DEVIATION REQUEST
AND DECISION FORM IN
ASSOCIATION WITH
AREQUEST FOR A PUD
MODIFICATION FROM
THE ECM

Project Name: Copper Chase at Sterling Ranch Fil No. 1

DEVIATION EXHIBIT: # OF PED RAMPS AT T-INTERSECTION

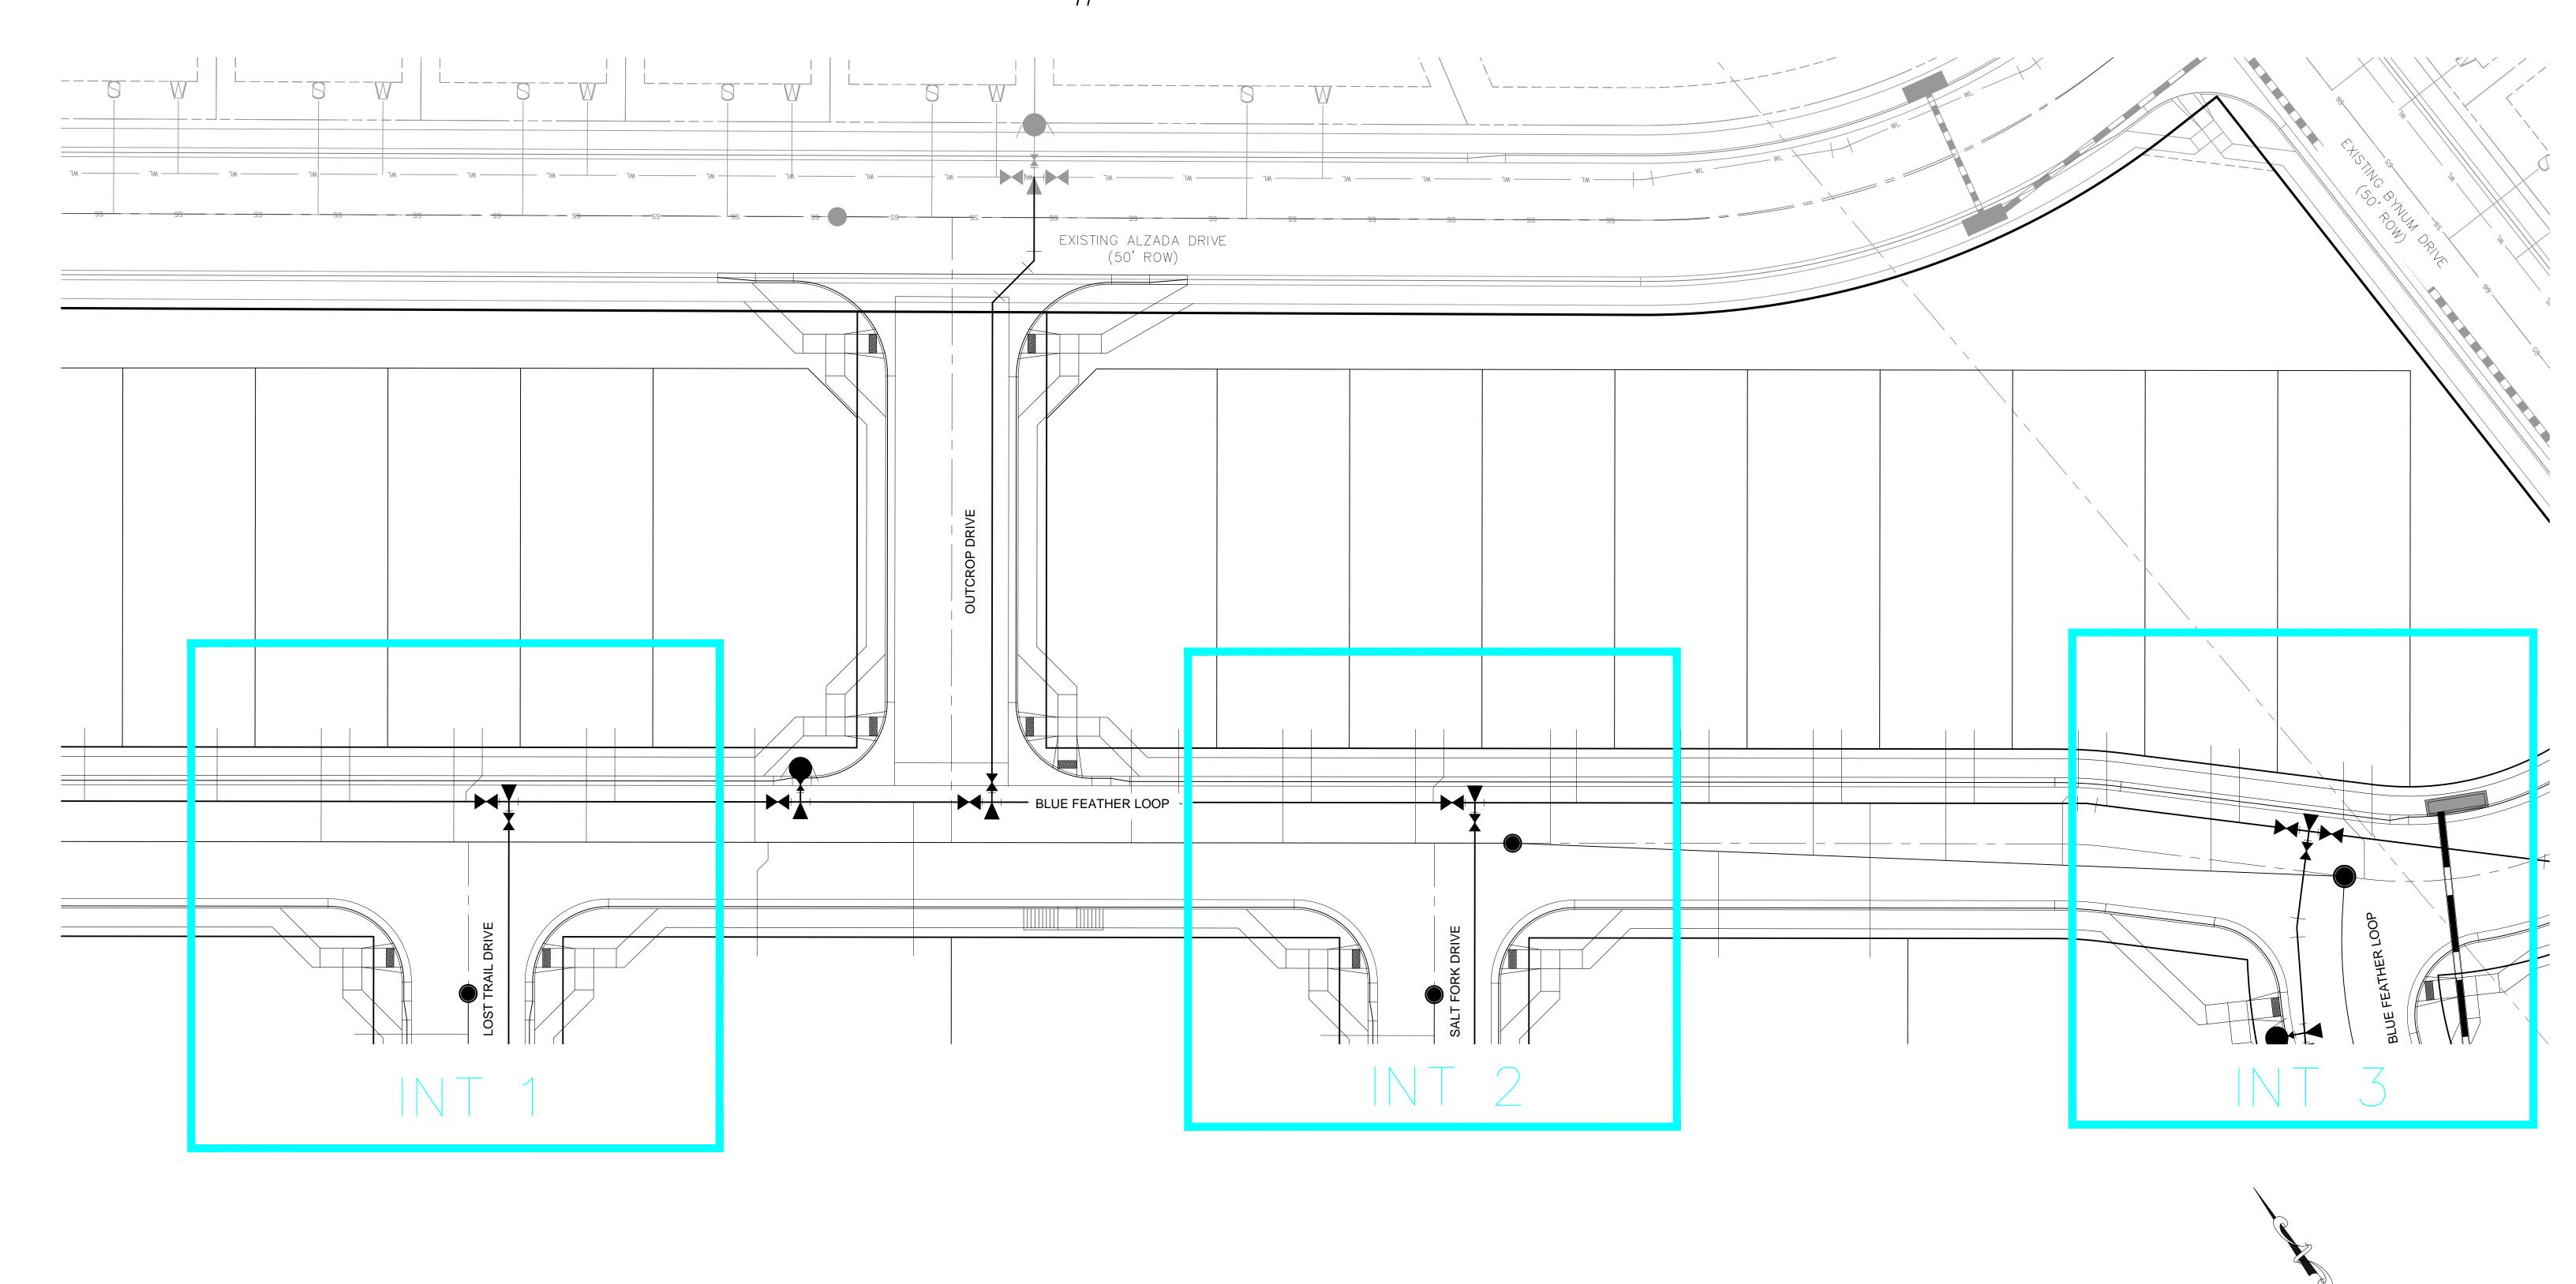
The proposed layout includes the following deviation(s) from standard ECM Standards for the number of PED ramps at a "T" intersection. Requesting;

- 2 PED ramps at Blue Feather Loop and Lost Trail Drive northeastern intersection.
- 2 PED ramps at Blue Feather Loop and Salt Fork Drive northeastern intersection.
- 2 PED ramps at Blue Feather Loop and Blue Feather Loop intersection.

The PED ramps at the southeastern end of these intersections will be installed as required. Installation of all required PED ramps at the northeastern end is not logical since it would create additional conflict points for pedestrian and vehicular travel paths due to the close proximity of the intersections. It is also not feasible to have these additional PED ramps due to the smaller lot geometry and associated features such as driveway requirements and lot density. As an alternative solution to these problems, one PED ramp will be constructed at a central point between the locations to create a comparable pedestrian circulation path that does not impede pedestrian movements and creates safer pedestrian crossings.

The deviation meets the control measure requirem	nents of Part I.E.3 and Part I.E.4 of the County's MS4 permit,	as applicable.
Stormwater quality requirements will be met regard	dless of PED ramp elimination.	
REVIEW AND RECOMMENDATION:	2.5.2.C.3 —	
A		
Approved by the ECM Administrator This request has been determined to have met the er	ritaria for approval. A deviation from Section	of the ECM is
This request has been determined to have met the cr hereby granted based on the justification provided.	iteria for approval. A deviation from Section	OI THE ECIVI IS
	_	
Γ	1	
L	7	
Denied by the ECM Administrator		(II = 5011)
This request has been determined not to have met cr	iteria for approval. A deviation from Section	of the ECM is
hereby denied.	_	
Γ	٦	
L	J	
FOR A DMINISTRATOR COMMENTS/CONDITIONS	٠.	
ECM ADMINISTRATOR COMMENTS/CONDITIONS	o: rd of County Commissioners approves the Planned Unit Devo	alanmant
